CONTRACT CHANGE ORDER MEMORANDUM

TO: DEANNA VILCHECK / JEANNETTE BALDERRAMOS			FILE: E.A. 04 - 0120M4
FROM: JEANNETTE BALDERRAMOS			CO-RTE-PM 04-ALA-80-1.6/2.7
			FED. NO. NO FED AID
CCO#	SUPPLEMENT#:	Category Code:	CONTINGENCY BALANCE (incl. this change)
1	0	AJZZ	\$5,079,361.00
COST: \$250,000.00		INCREASE <input checked="" type="checkbox"/> DECREASE <input type="checkbox"/>	HEADQUARTERS APPROVAL REQUIRED? <input type="checkbox"/> YES <input checked="" type="checkbox"/> NO
SUPPLEMENTAL FUNDS PROVIDED: \$250,000.00		IS THIS REQUEST IN ACCORDANCE WITH ENVIRONMENTAL DOCUMENTS? <input checked="" type="checkbox"/> YES <input type="checkbox"/> NO	
CCO DESCRIPTION: Flagging & Traffic Control			PROJECT DESCRIPTION: CONSTRUCT BRIDGES AND ROADWAY, AND ELECTRICAL SYSTEM
Original Contract Time:	Time Adj. This Change:	Previously Approved CCO Time Adjustments:	Percentage Time Adjusted: (including this change)
1140 Day(s)	0 Day(s)	0 Day(s)	0 %

CCO DESCRIPTION: Dispute Review Board (Caltrans Portion)		PROJECT DESCRIPTION: CONSTRUCT BRIDGES AND ROADWAY, AND ELECTRICAL SYSTEM		
Original Contract Time: 1140 Day(s)	Time Adj. This Change: 0 Day(s)	Previously Approved CCO Time Adjustments: 0 Day(s)	P

ALL DIMENSIONS ARE IN METERS UNLESS OTHERWISE SHOWN
CONTOUR GRADING
SCALE 1:500

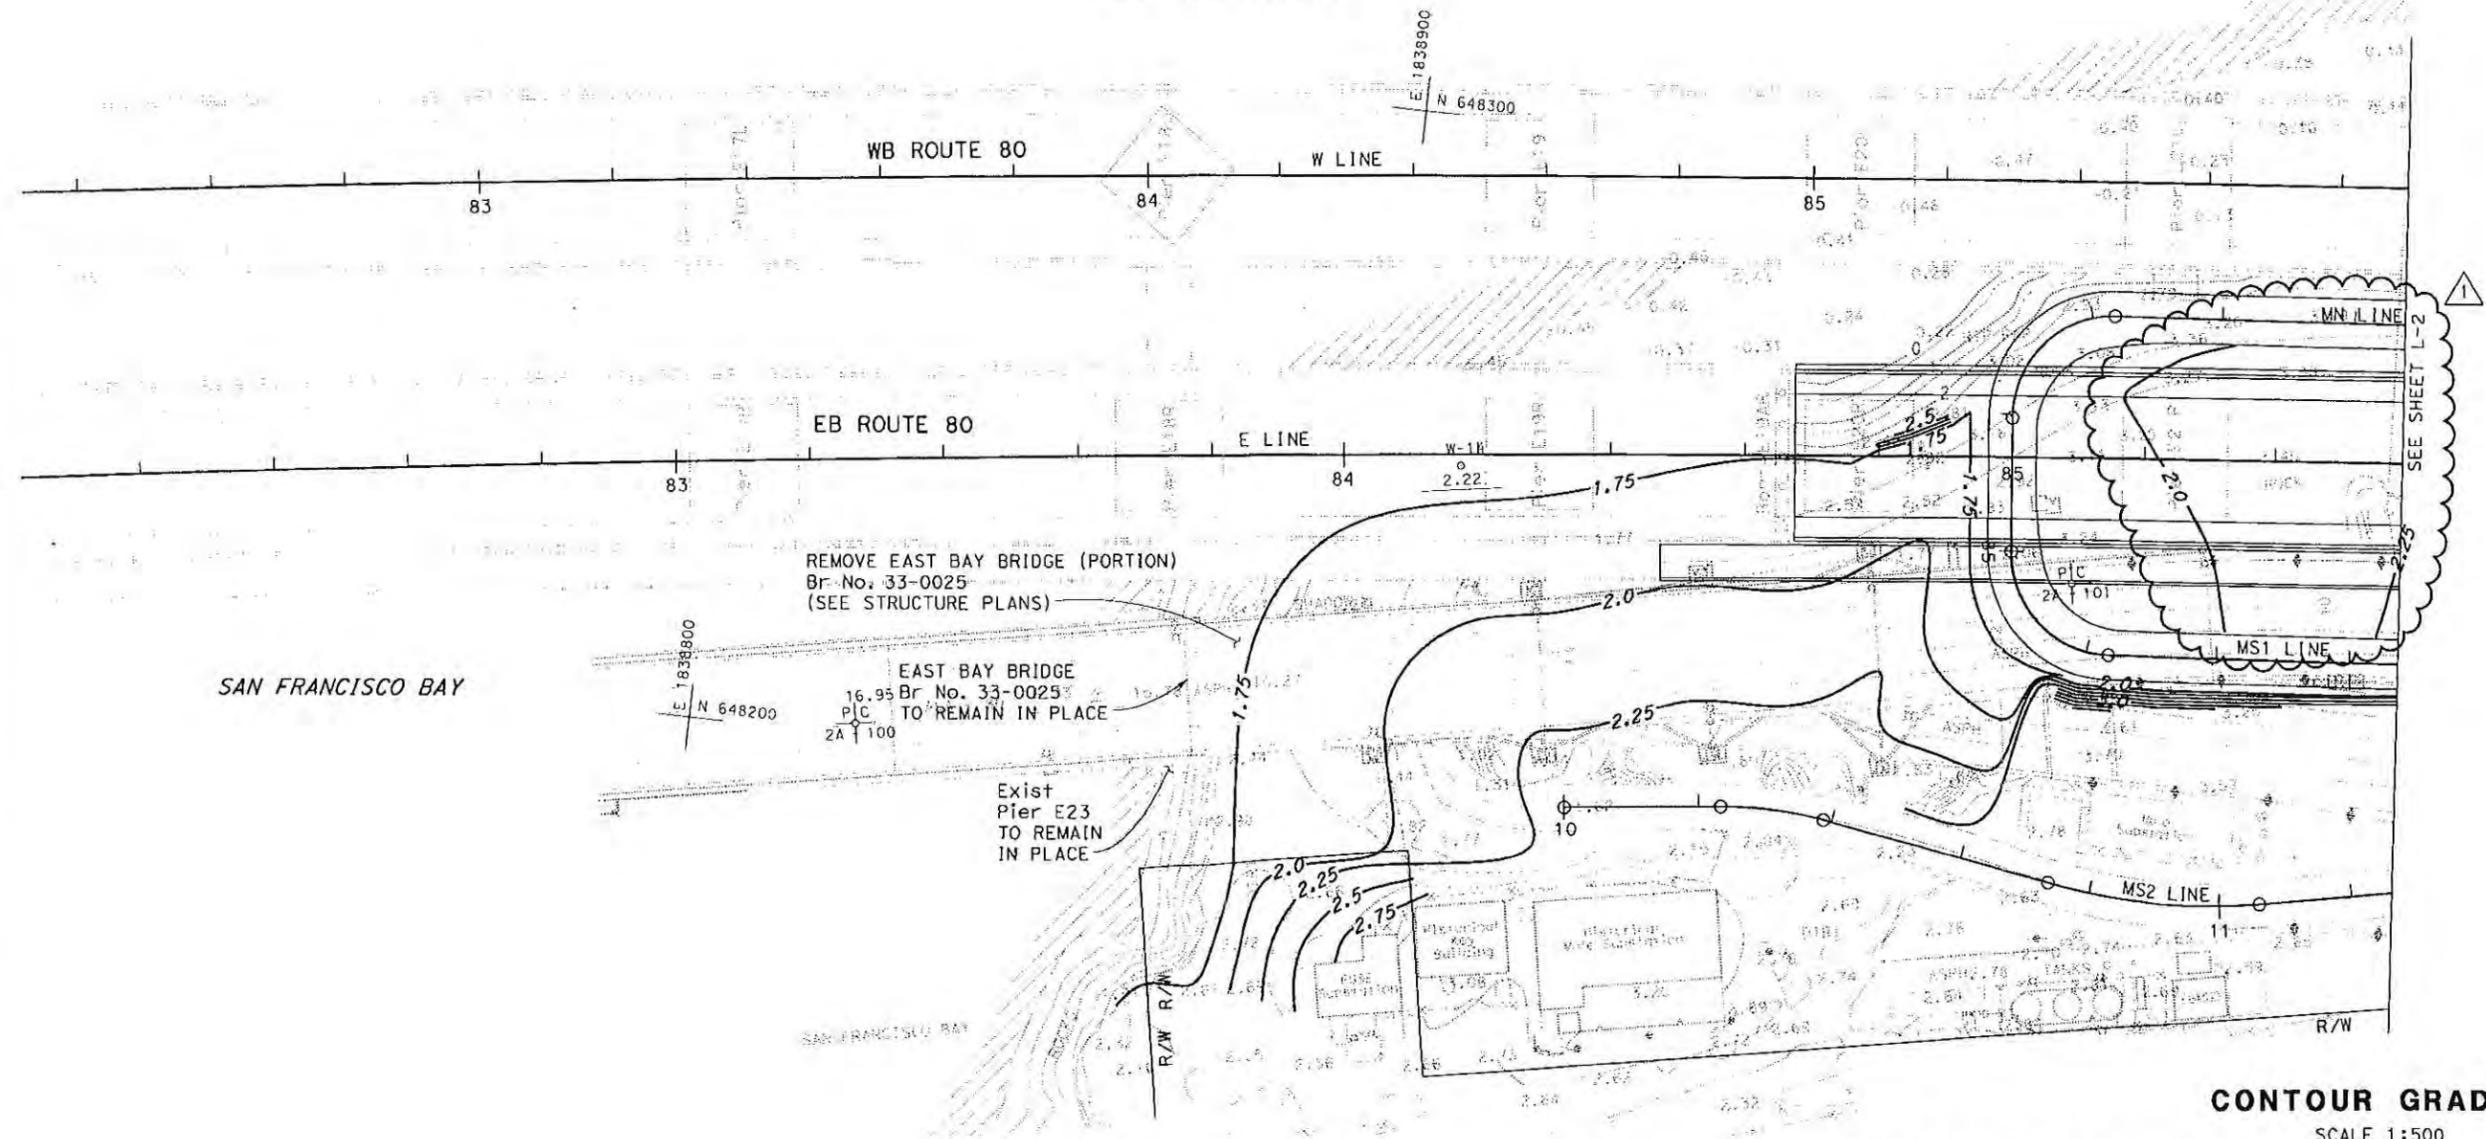
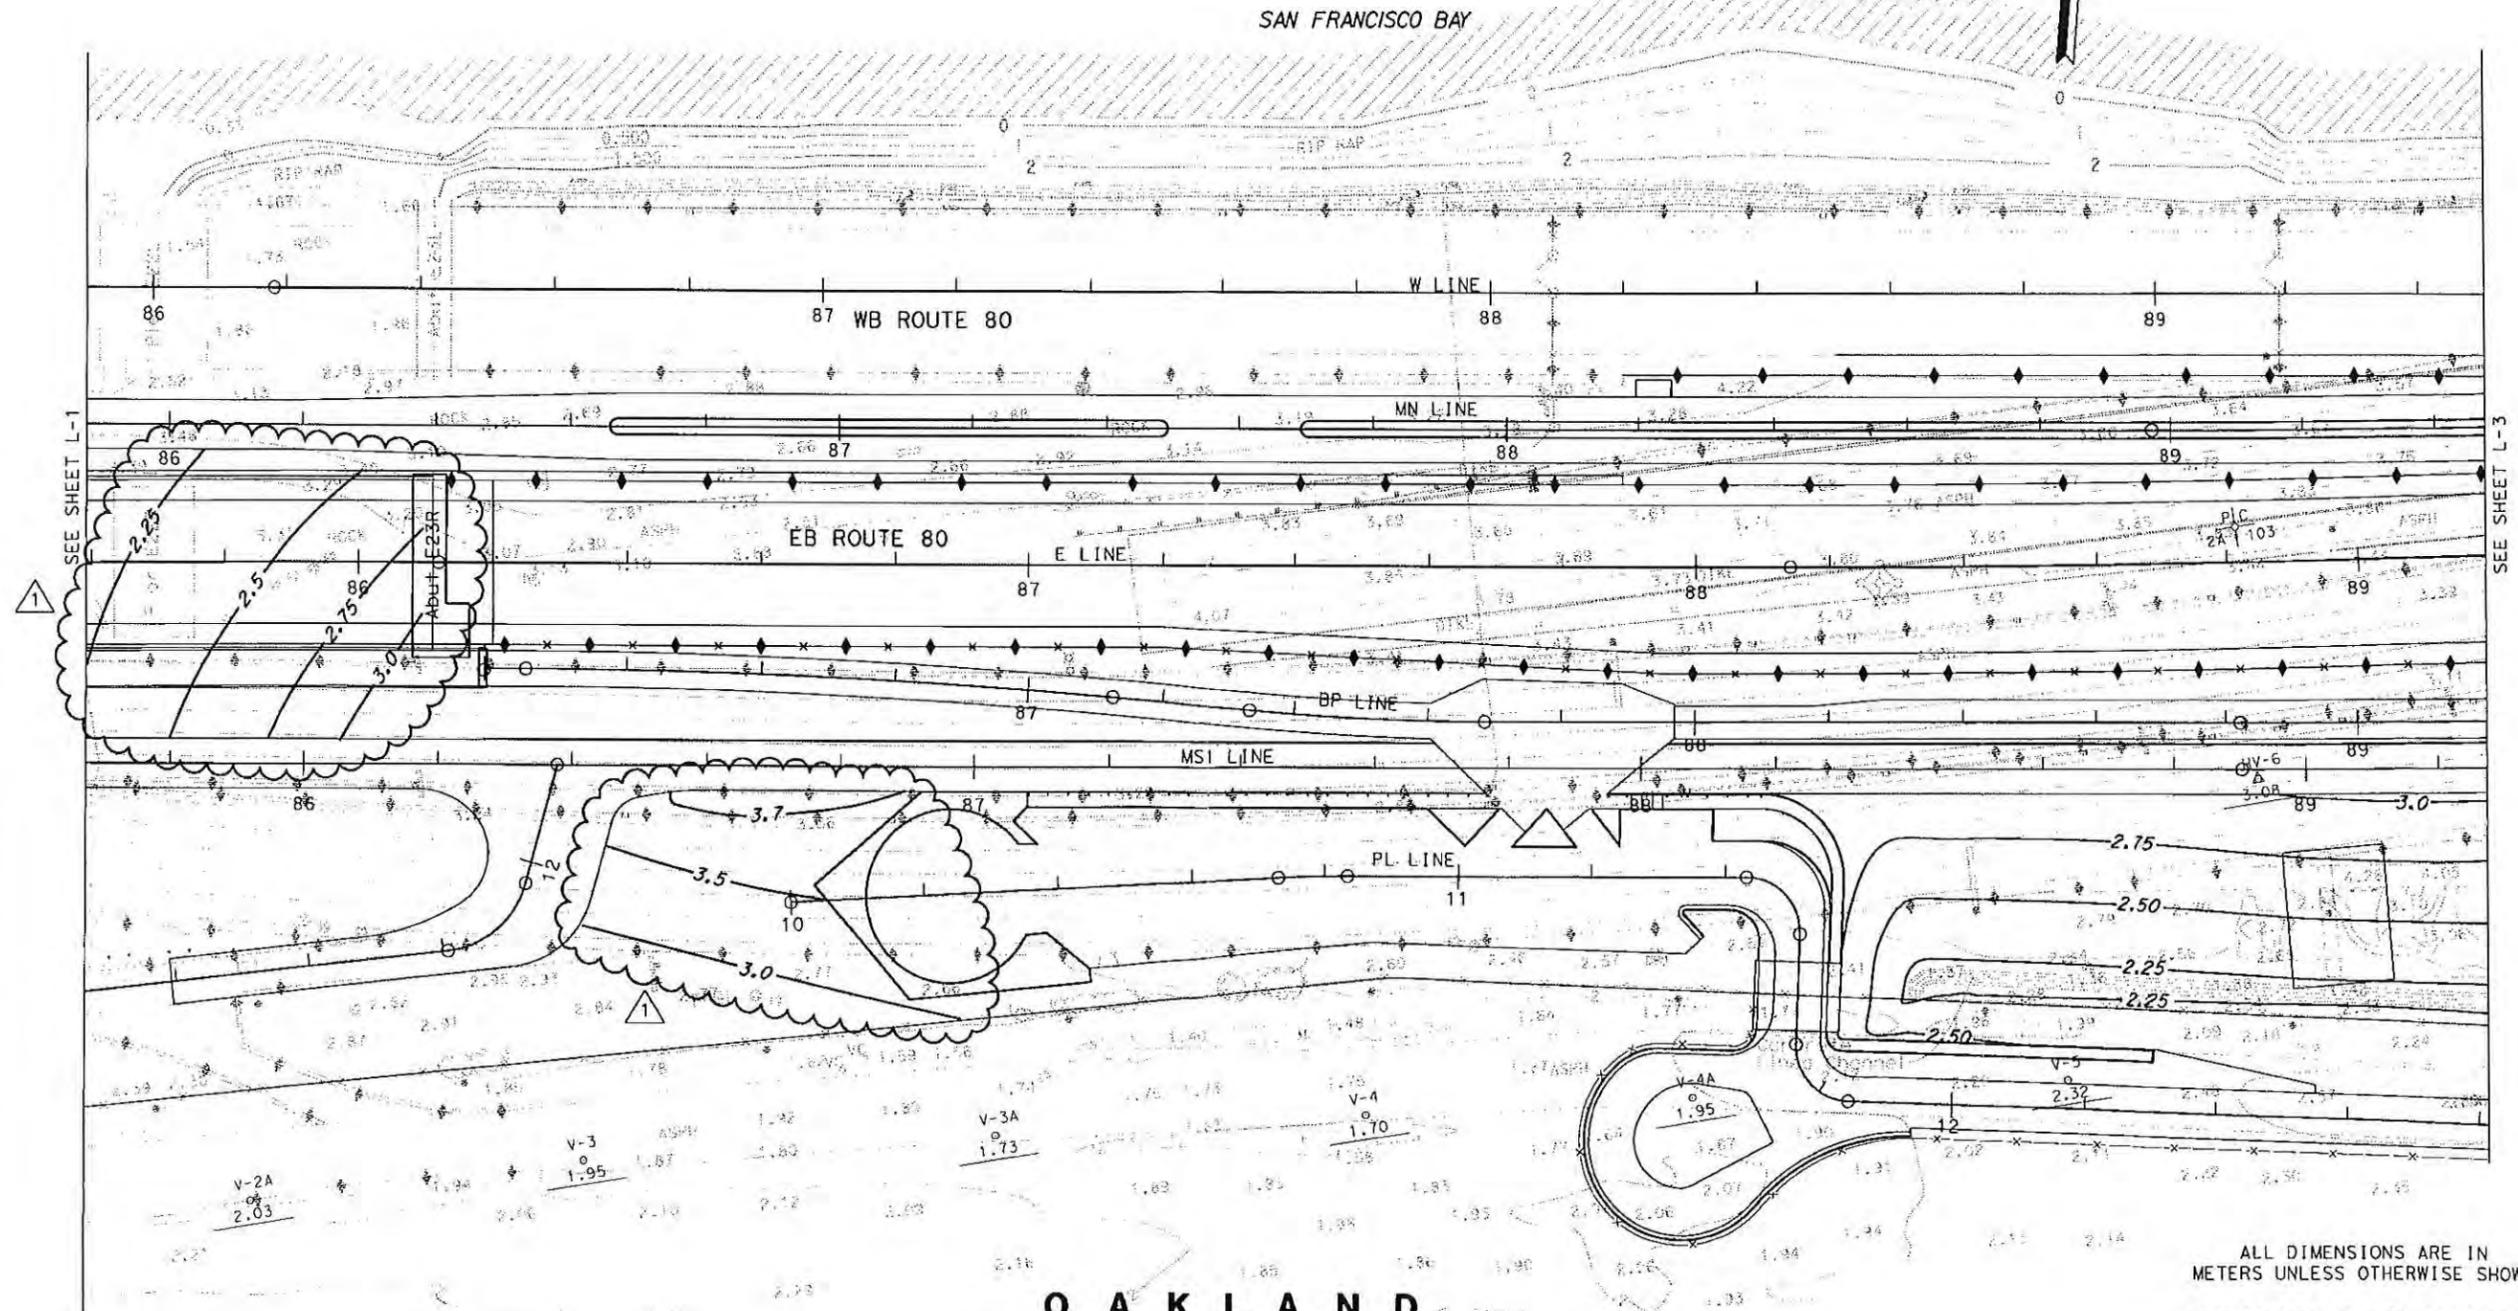
Revise site grading per revised contract drawings 62R1 and 63R1 (Attached sheets 3 and 4 of this change order), including adding contour grading as shown, and grading area between the new MN and MS1 line located underneath the new eastbound bridge structure. Excess soil will be hauled off site.
